Access Audit

Common parts of Petticoat Square
Artizan Street
London

Prepared on Behalf of
City of London

Date: 26th January 2022

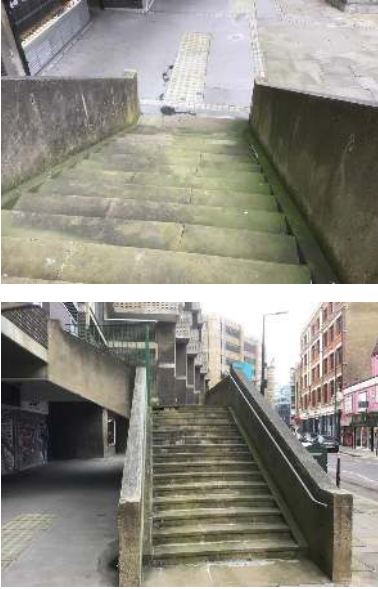
1.9	<p>City of London bollards have well contrasted markings around the head of each bollard making them easier to identify by a visually impaired person.</p>

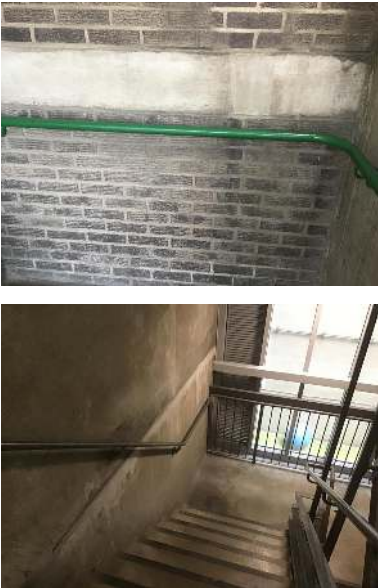
It was difficult to assess light levels to the podium stairs as these are generally set externally or in glazed enclosures so, in daylight hours natural light is plentiful.

However given the number, type and position of luminaires and the marginal lux readings taken during our visit we find it unlikely that 100lux will be achieved at the tread throughout making it more difficult for a visually impaired user to identify key features such as step edges and handrails.

Best practice recommends that a lux level of 100lux is achieved at tread level.

Review and install additional luminaires to achieve 100lux at tread to podium stairs

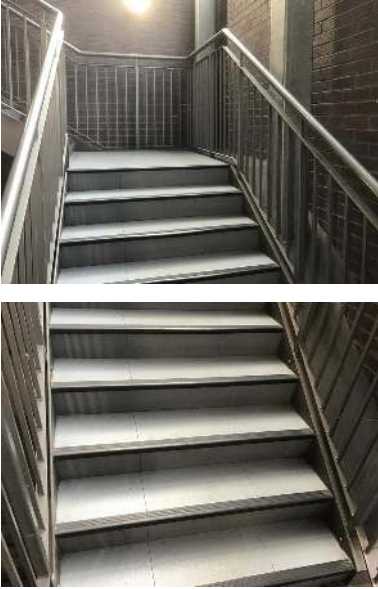
Photo	Item	Issues	Recommendations	P	£
	5.3	<p>Stairs generally have handrails of a suitable profile to either side providing a good means of support for a mobility impaired user and visual clue of the flights.</p> <p>The green colour to the podium and grey to the tower could achieve better tonal contrast against the walls by using a lighter tone.</p> <p>When repainting we'd suggest you consider a different colour to each stair consistent with the colour coding of entrances as set out previously which will give a useful wayfinding clue to a visually or mentally impaired user.</p>	<p>Paint handrails in contrasting colour</p>	3R	Zero
	5.4	<p>Ideally handrails would be warm to the touch as cold rails will prove difficult to grip by some users with sensitive hands such as someone with arthritis but in this setting the low maintenance steel rails do seem appropriate.</p>

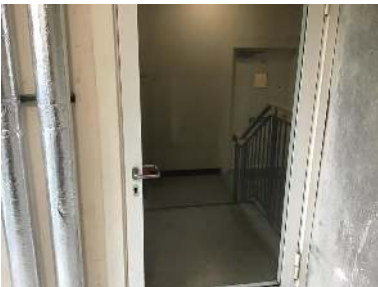
9.6	<p>Flat entrance doors to the tower in particular tend to be poorly contrasted against wall surfaces making the openings difficult to identify by a visually impaired person. The anonymous nature of the openings may also prove confusing to a resident with a mental impairment.</p>	<p>This can be addressed by painting the walls, architraves or doors in a contrasting colour.</p> <p>A 30 point difference in light reflectance values of adjacent surfaces should be achieved. These values are readily available from paint suppliers.</p> <p>This is a matter to be dealt with reactively in this setting and the painting of doors would likely prove a reasonable adjustment upon request by a resident.</p>
